# SERVICE BULLETIN No.1183

<b>COACH MODEL</b>	: C2045
<b>BULLETIN TYPE</b>	: Product Improvement
<b>SECTION</b>	: Section 9 – Electrical system
<b>DATE</b>	: May 4, 2006
<b>SUBJECT</b>	: <b>Headlamp assembly - seals</b>
<b>TERMS &amp; CONDITIONS</b>	: No claims will be accepted with reference to this Bulletin.

**Figures 5 and 6: Part to be removed from the bottom of the outside bowl (dimensions are approximate)**

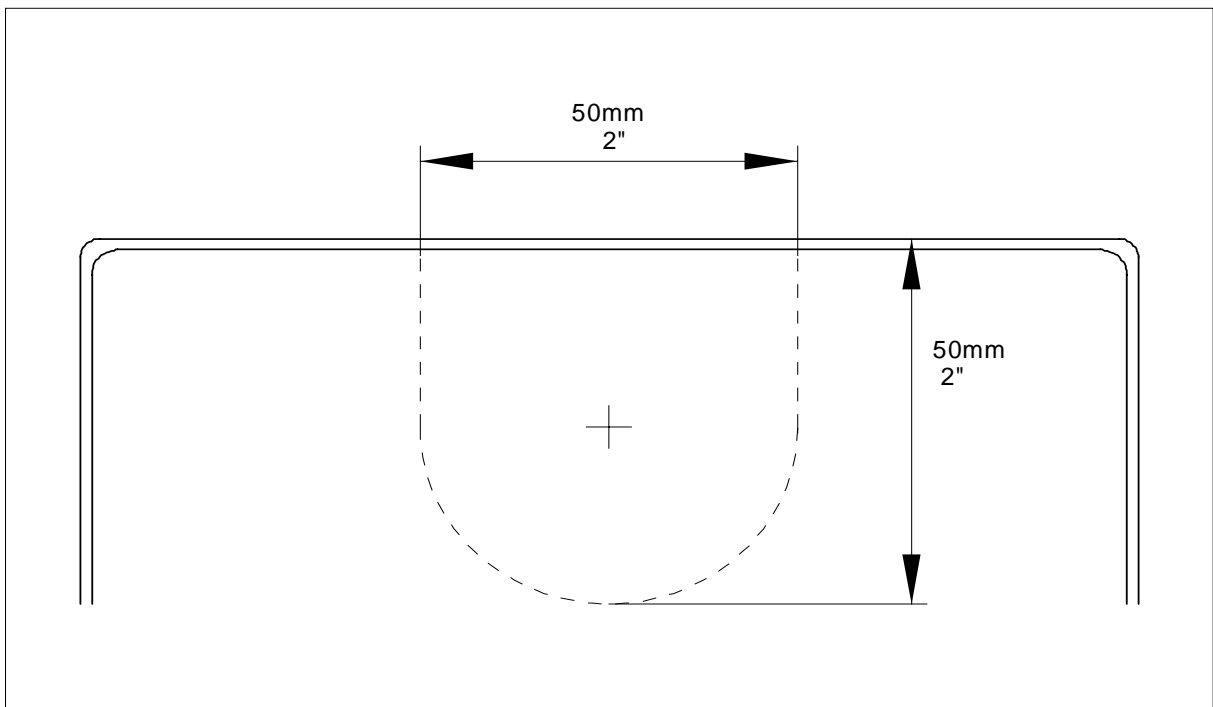
- 6) Carefully remove the lamp assembly from the coach.
- 7) Referring to Figures 5 and 6, mark the area to be removed from the bottom rear part of the outside bowl.

**Figure 8: Drilling the outside headlamp bowl**

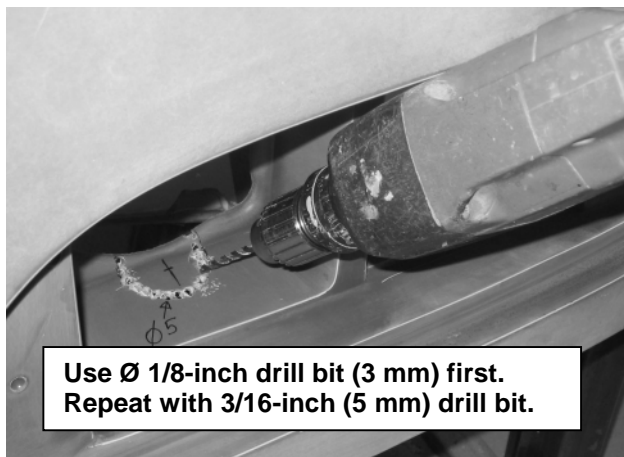
- 8) Using a 1/8-inch drill bit, drill holes within the confines of the marked area (see Figure 8). Repeat this step using a 3/16-inch drill bit.

**Figure 9: Drilling the inside headlamp bowl**

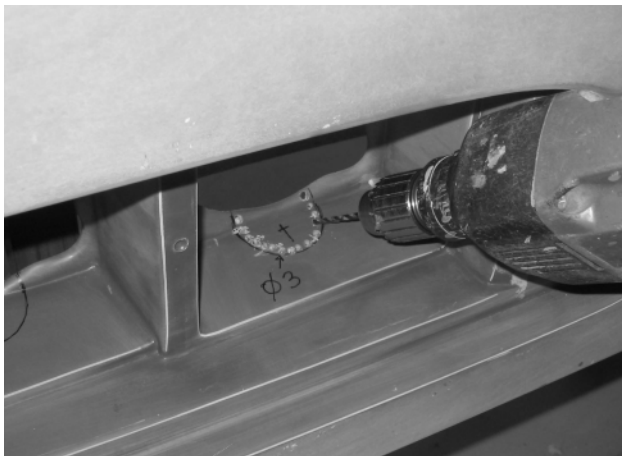
- 9) Repeat steps 7 and 8 for the inside bowl (see Figure 9).

**Figure 11: Dressing the edges**

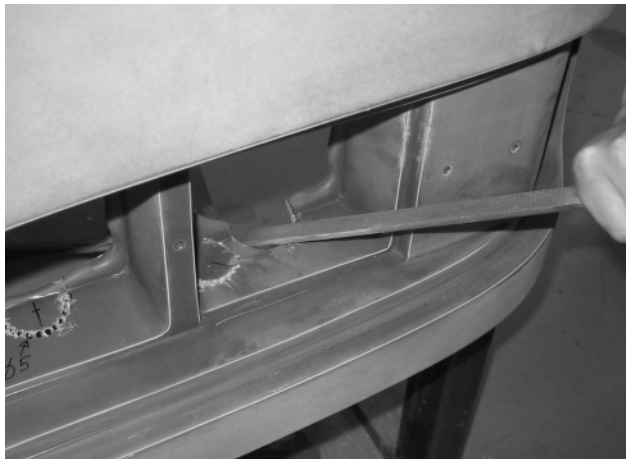
10) Dress the edges of the apertures with a file (see Figure 11).

**Figure 18: Headlamp seal – final installation**

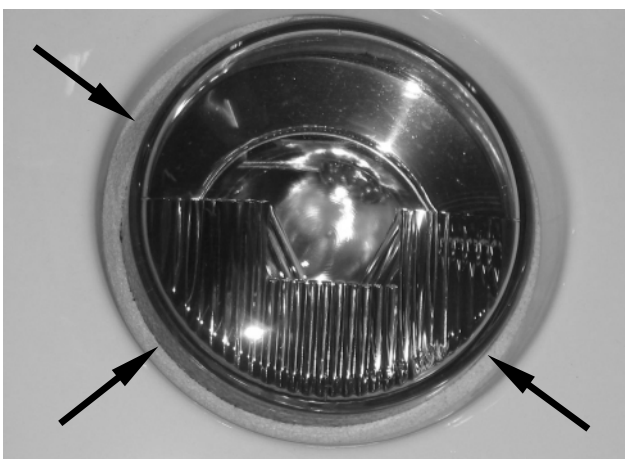
- 15) Before reinstalling the bezel, check that the flat washers are fitted to the mounting studs (see Figure 16).  
 Reinstall the bezel starting at the outside hole (see Figure 17).  
 Secure hand tight with washers and wing nuts.  
 Figure 18 shows the final seal installation.
